The Alaskan Way Viaduct & Seawall Replacement Project

A Retrofit is Not Enough

Several proposals have been made to retrofit the Alaskan Way Viaduct. A specific proposal was made by Victor Gray and the Viaduct Preservation Group in December 2004. WSDOT hired T.Y. Lin International to conduct an independent review of the proposal to determine if it would meet the earthquake standards used for Washington state bridges.

Shown in red is the expected damage for the design for 500-year earthquake.

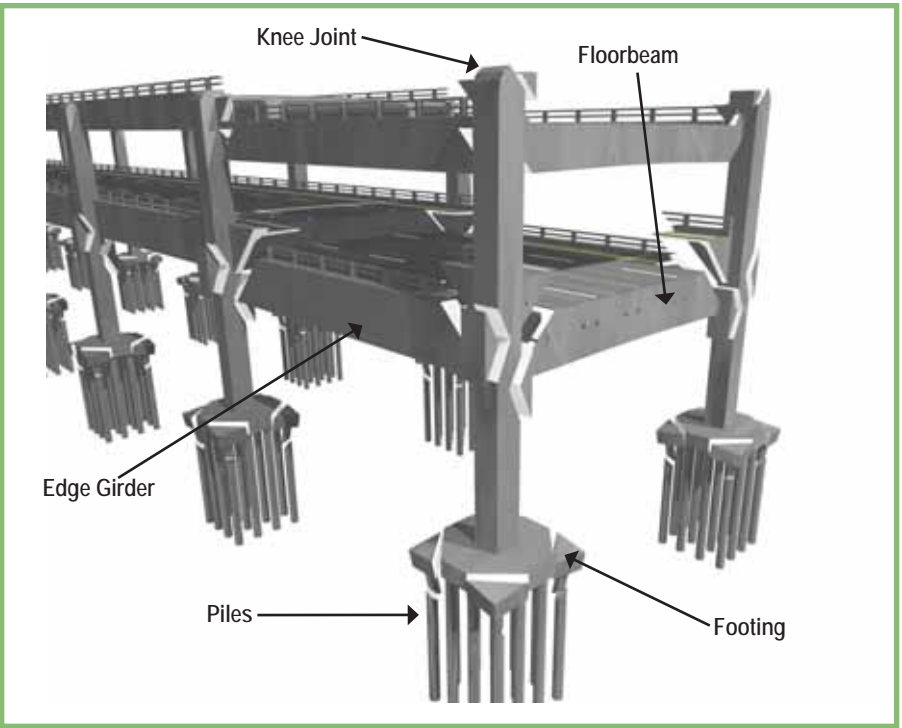
For the very bad earthquake, the evaluation shows that the retrofitted viaduct will collapse, likely causing loss of life. The reasons for this collapse are:

- The footings of the viaduct would be subject to higher shear and flexural demands, and higher joint shears than for the bad earthquake. Severe damage of the footings is likely.
- The piles would be subject to higher compressive forces that cause severe damage to the footings.
- The columns will rock on the pilings, which they were not designed to do. This rocking may result in severe impacts to the adjacent viaduct sections. The columns are very brittle and the loads from the rocking plus the damage to the footings would likely cause the viaduct to collapse.
- Other parts of the viaduct will also be severely damaged and could fail. For example, the floorbeams will suffer from negative bending at the connection with the columns. The knee joints – some of which failed in the Nisqually earthquake – could also fail

The viaduct has many weak points that could cause it to collapse in a very bad earthquake.
